# **VTA's BART SILICON VALLEY— PHASE II EXTENSION PROJECT HYDROLOGY AND WATER QUALITY TECHNICAL REPORT**

November 2017

## E.1 Introduction

**Figure 1**  
**Regional Location (Revised)**  
 VTA's BART Silicon Valley-Phase II Extension Project

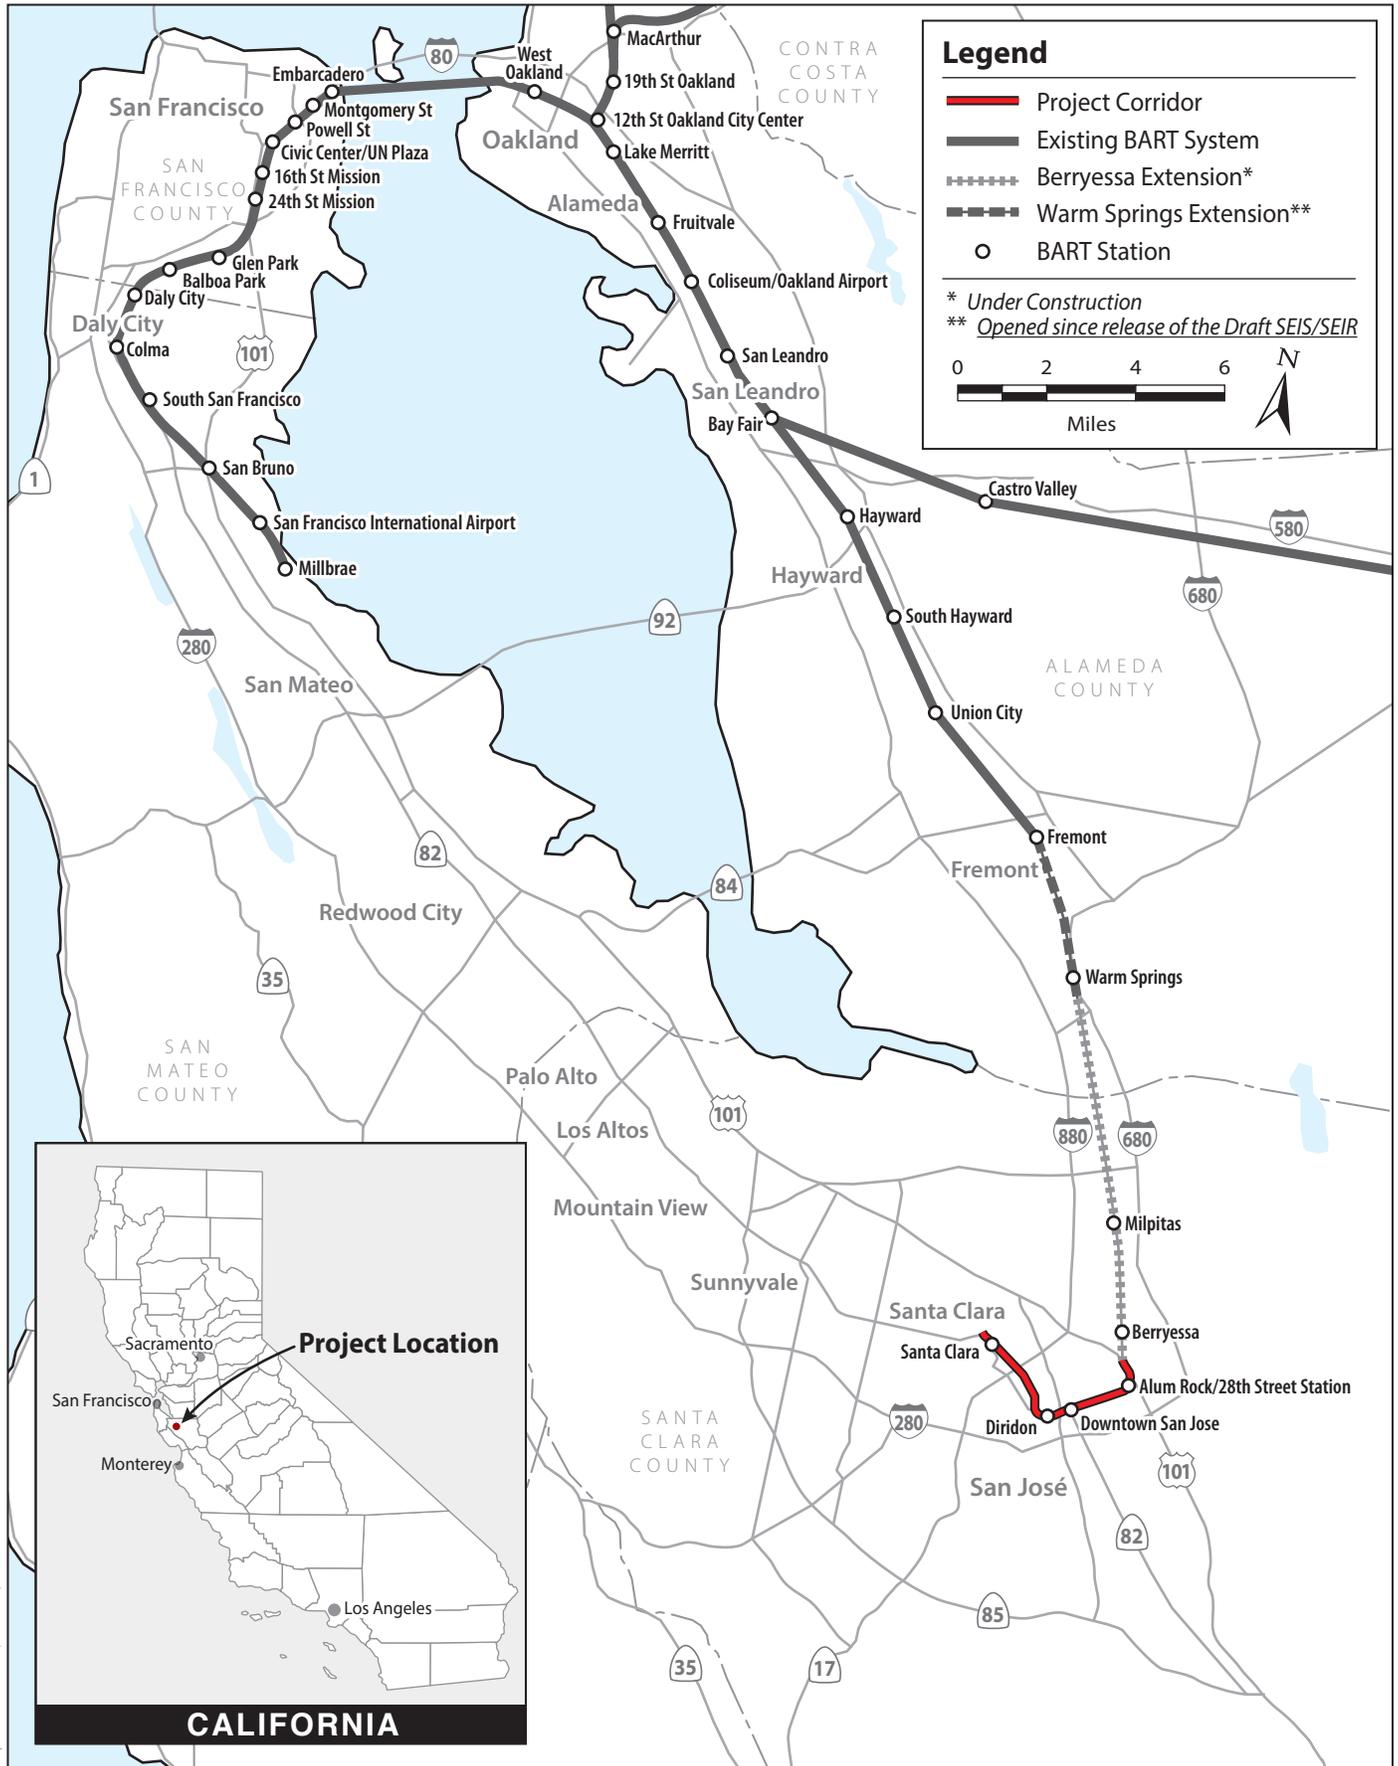
Two station names from the Phase I Extension have been renamed: Berryessa Station (or Berryessa BART Station) is now Berryessa/North San Jose Station. Milpitas BART Station is officially the Milpitas Station.

The revised Chapter 1, *Project Description*, is provided below.
